Subject: Collin County Healthcare Facility, Parking Garage, and Medical Examiners
PCO No. 146; RFI #483 PG West Tower Coiling Door Conflicts

Issue No. 146 - RFI #483 PG West Tower Coiling Door Conflicts Amount

RFI #483: PG - Main Tower West Rolling Door

POST BASE PLATE LAYOUT

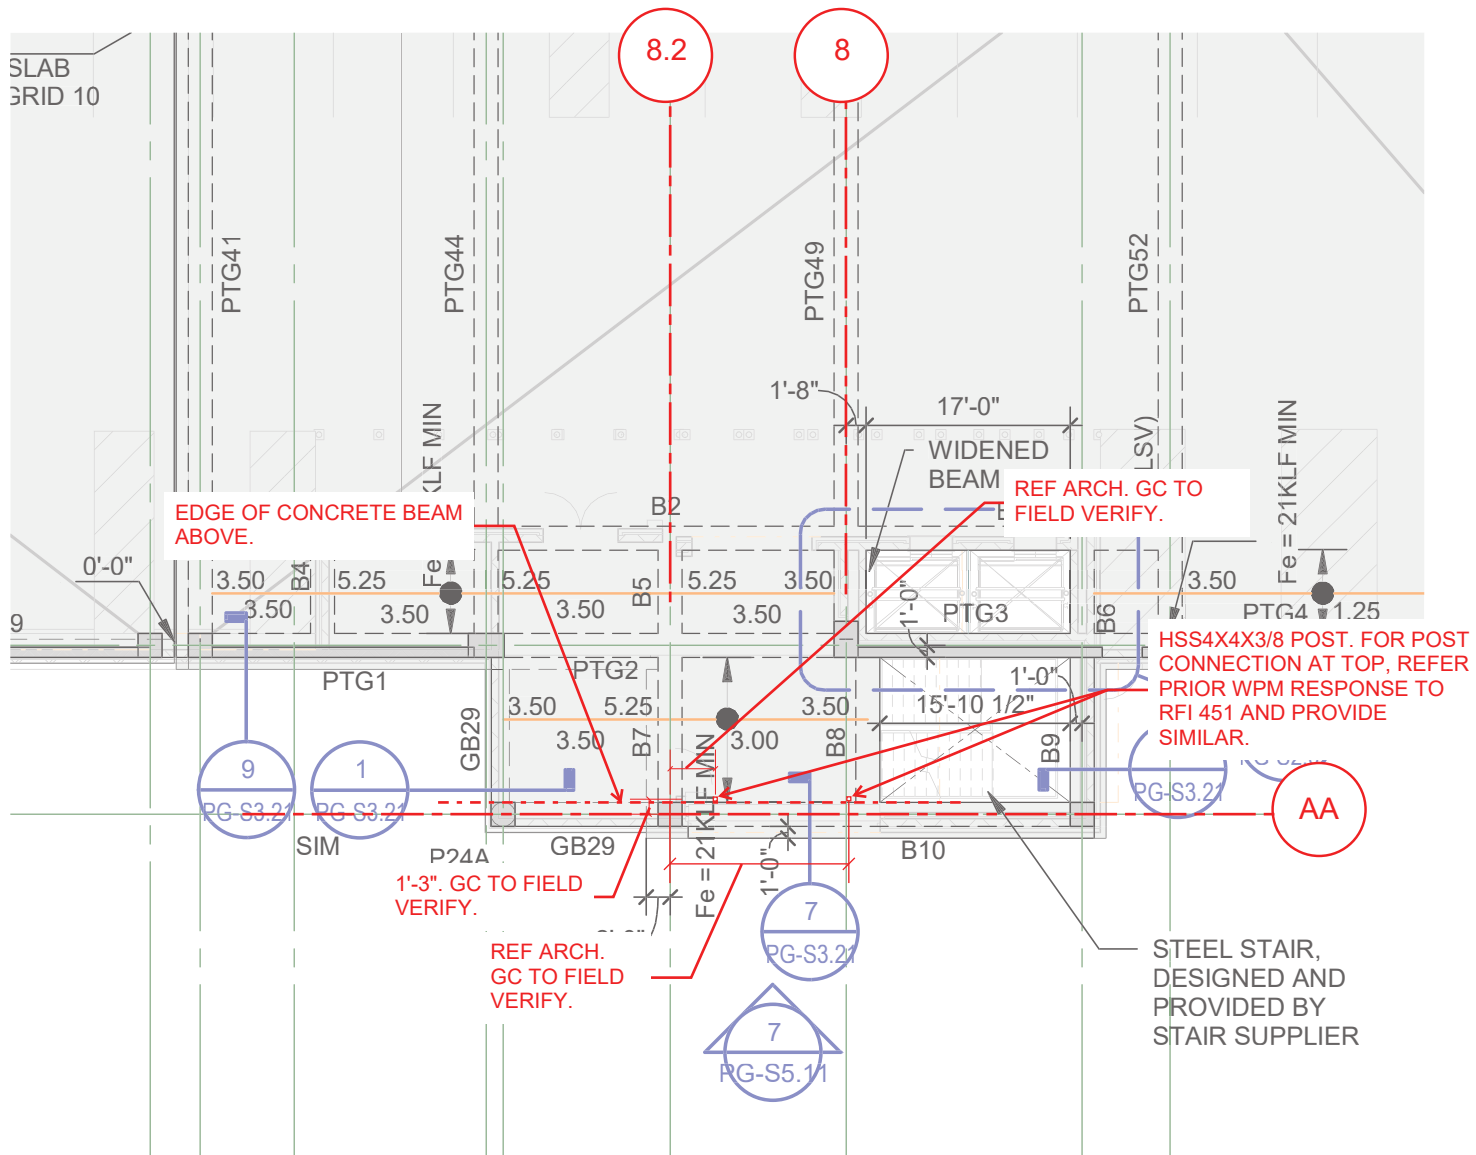
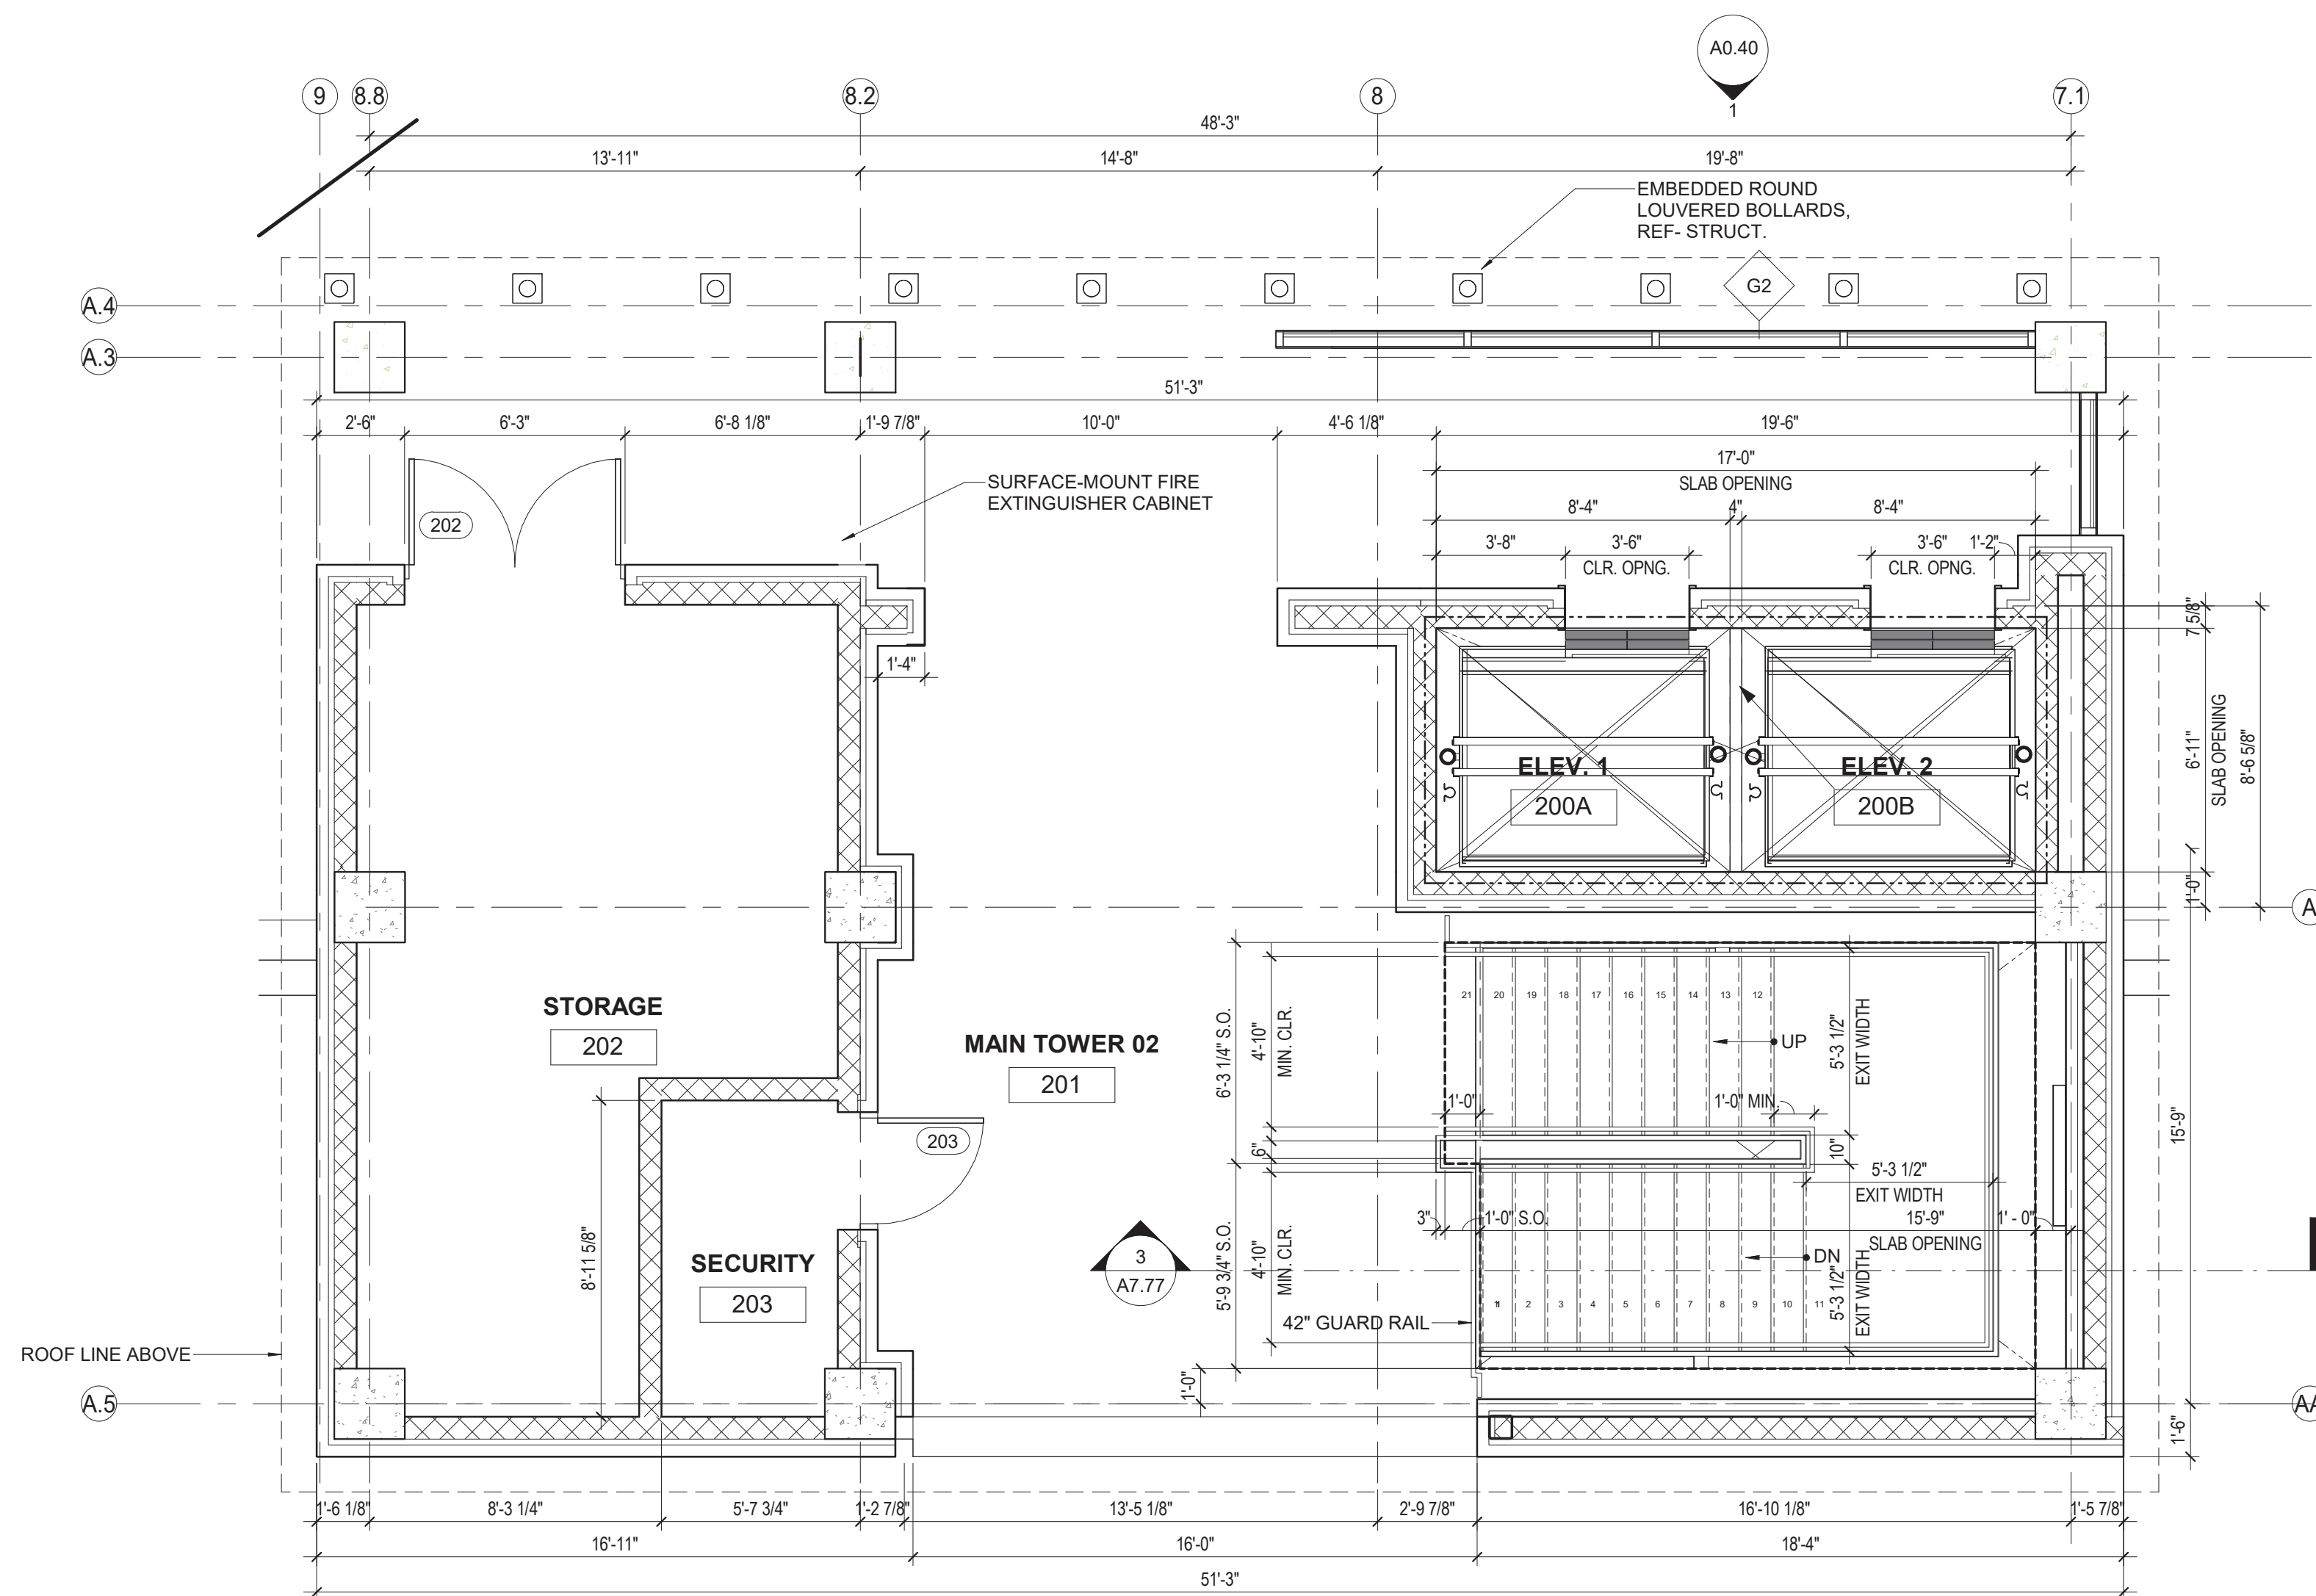
SEE STRUCTURAL DETAILS ATTACHED. WPM HAS ASSUMED THAT THE NEW OH DOOR'S HOOD WOULD SPAN FROM POST TO POST SIMILAR TO OTHER OH DOORS PER RFI 451.

DOOR 104

PROVIDE 1/2X7X1'-0" W/(4) 3/4" DIA HILTI KWIK
BOLT TZ2 - SS304 WITH 3-1/4" EMBEDMENT INTO
EXISTING CONCRETE. BASE PLATE ON 1-1/2" NS
GROUT. GC TO SCAN EXISTING CONCRETE PRIOR
TO DRILLING, TO AVOID CONFLICTS WITH PT
TENDONS AND REBAR.

WEST ELEVATION 1/16" = 1'-0" 4

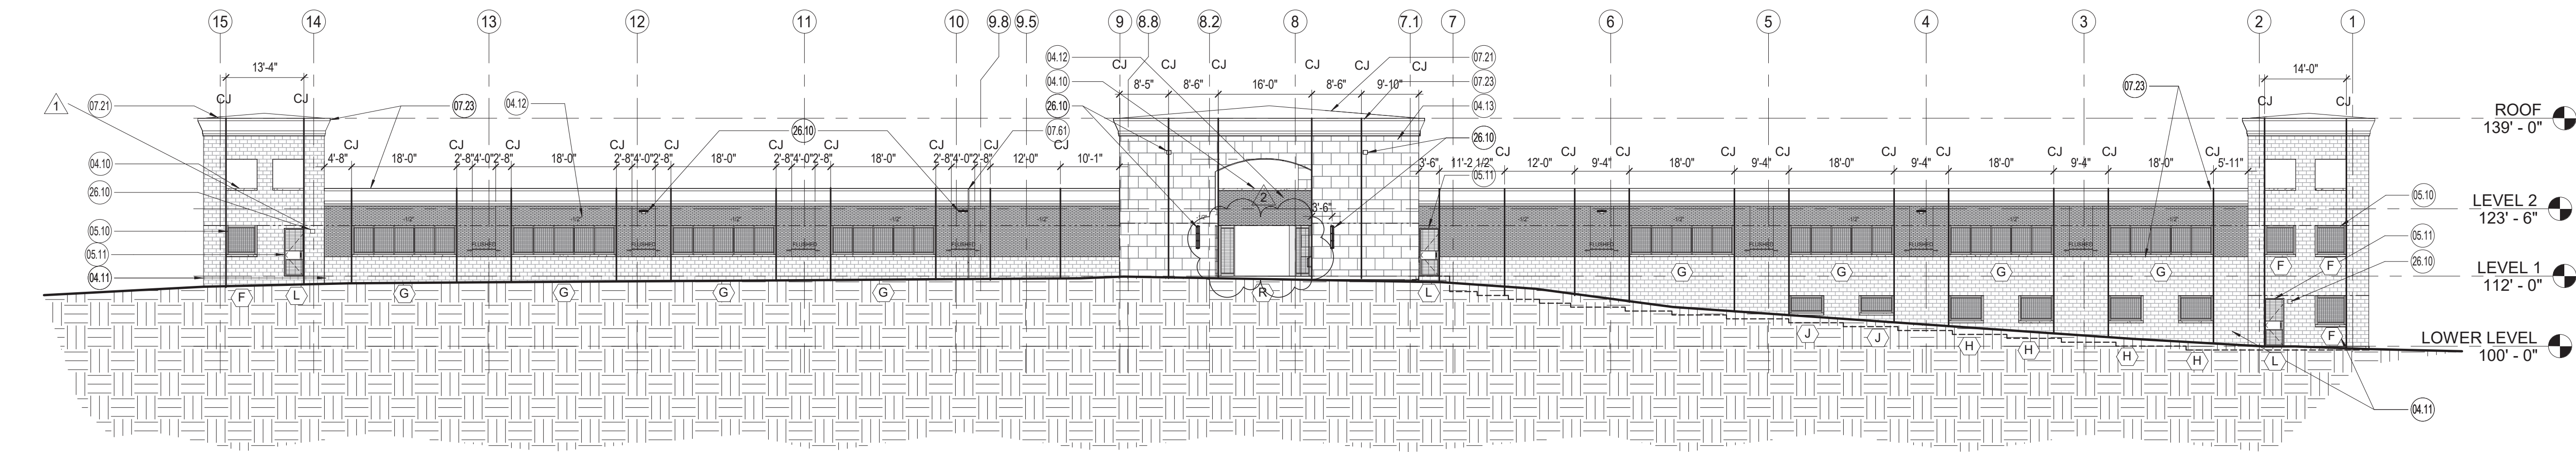
Question	Question from Carolina Haylow The Christman Company (DFW) on Wednesday, May 27, 2026 at 04:31 PM CDT Question Pending from RFI #451. Main Tower Rolling Door (Plaza Connection): Installing the overhead rolling door behind the beam as detailed will result in a gap between the door and adjacent construction, creating an incomplete enclosure. This condition is not addressed in the contract documents. Photos illustrating the condition and resulting gap are attached for reference
Official Response	Response from Reynaldo Herreros PGAL on Friday, Jun 26, 2026 at 04:05 PM CDT Per Ruthwik via email: Refer RFI 451 response from WPM for post connection at the top and provide similar for the wire mesh panel posts. See prior structural response to RFI 483 for post bottom connection and provide similar.

Refer RFI 451 response from WPM for post connection at the top and provide similar for the wire mesh panel posts. See prior structural response to RFI 483 for post bottom connection and provide similar.
